Urgent Field Safety Notice

Claria MRI™ CRT-D SureScan™ and Amplia MRI™ CRT-D SureScan™

December 2016

Medtronic reference: FA747

Figure 1

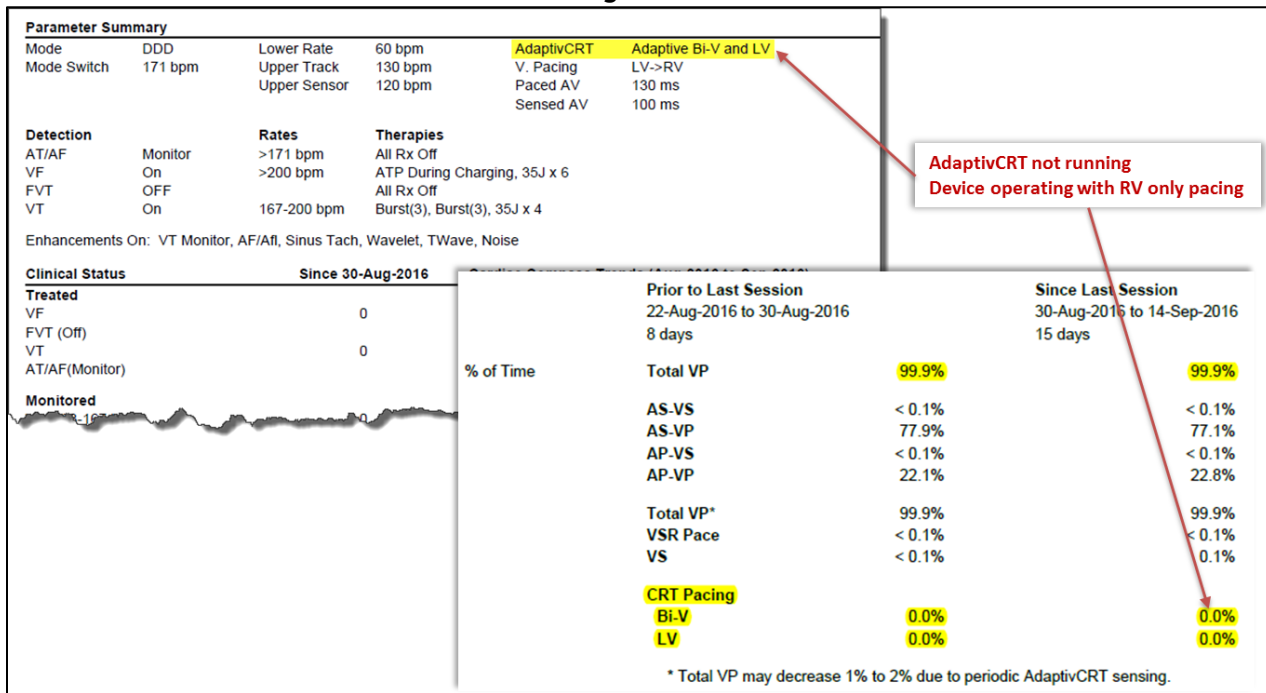
When a patient with AdaptivCRT enabled (shipped setting) is subsequently programmed to MVP mode and then re-programmed back to DDD or DDDR, AdaptivCRT is not re-enabled. When this programming sequence occurs, LV pacing is not delivered, despite parameters indicating AdaptivCRT is enabled (Appendix B, Figure 1). This will result in RV only pacing which may be undesirable for the patient. LV pacing will remain disabled until a specific programming sequence is manually completed; refer to the Patient Management section of this letter (Appendix B) for details.

- If the CRT setting is currently programmed to *Adaptive Bi-V and LV* or *Adaptive Bi-V* (Figure 1), review rate histogram CRT Pacing percentages (CRT Pacing: Bi-V and LV).
- If Bi-V and LV pacing percentages *Since Last Session* are both near 0%, then the device has encountered the programming sequence and has lost LV pacing; proceed to step 2.

Perform the following programming steps to restore the device to its expected operating state with AdaptivCRT enabled:

- Select the CRT parameter window, select *Nonadaptive CRT*, and select *PROGRAM*.
- Select the CRT parameter window, select the desired AdaptivCRT setting (*Adaptive Bi-V and LV* or *Adaptive Bi-V*), and select *PROGRAM*.
